Jackson District Library Horton Branch Remodel

Project #2362

ADDENDUM A

CLARIFICATIONS AND QUESTIONS

ES
ELECTRICAL
RISER DIAGRAM AND
PANEL SCHEDULES
SHEET TITLE

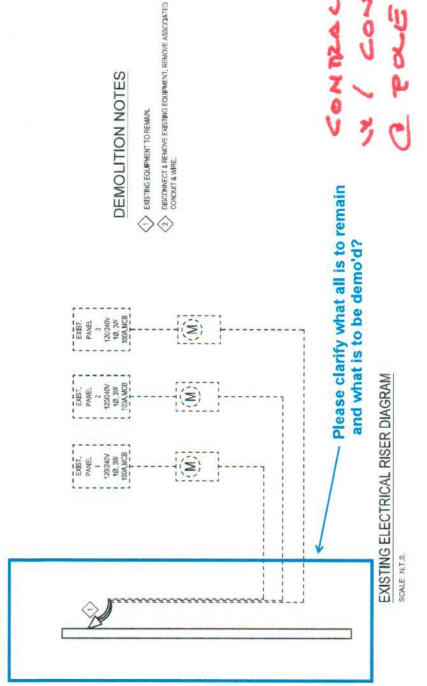
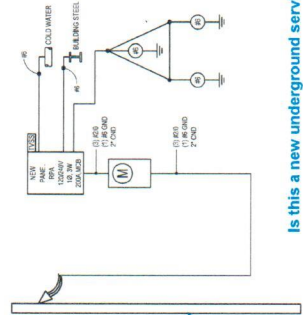
10. Question: *Clarification on the service entrance (see attachment)?*

Please clarify what all is to remain
and what is to be demo'd?

Is this a new underground service or overhead?

Is this the utility pole???

Answer: See attached redlined E5.

**CONTRACTOR TO COORDINATE
W/ CONSUMERS FOR WORK
@ POLE.**

YES
